Access Compliance Report Public Rights-of-Way (Pedestrian Signals)

Main Street: STREET_OF_THE_GOLDEN_LANTERN Cross Street: DANA_POINT_HARBOR_DR Location: SW

ADA ID: SGRK220208162639 Signal Type: One Push Button-Non APS Overall Compliance: No Severity Scores: BTN 1: 10 BTN 2: N/A No BTN: N/A

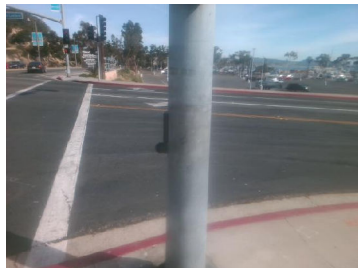
N/A Is Button 1 APS or Non-APS?	NonAPS	N/A Is Button 2 APS or Non-APS?	N/A
N/A B 1 VibroTact Arrow?	N/A	N/A B 2 VibroTact Arrow?	N/A
N/A B 1 VibroTact Parallel to Xing?	N/A	N/A B 2 VibroTact Parallel to Xing?	N/A
N/A B 1 VibroTact Contrast	N/A	N/A B 2 VibroTact Contrast	N/A
No B 1 Pilot Light?	No	N/A B 2 Pilot Light?	N/A
N/A B 1 Pilot Light Illumination?	N/A	N/A B 2 Pilot Light Illumination?	N/A
N/A B 1 Walk Indicator Type	N/A	N/A B 2 Walk Indicator Type	N/A
N/A B 1 Walk Indicator Audible?	N/A	N/A B 2 Walk Indicator Audible?	N/A
N/A B 1 Locator Tone?	N/A	N/A B 2 Locator Tone?	N/A
N/A B 1 Tone Audible Range?	N/A	N/A B 2 Tone Audible Range?	N/A
B 1 Addl APS Features?	No	B 2 Addl APS Features?	N/A
B 1 Addl APS Features Notes	N/A	B 2 Addl APS Features Notes	N/A

Possible Solutions: Replace Signal Push Button With APS Button.
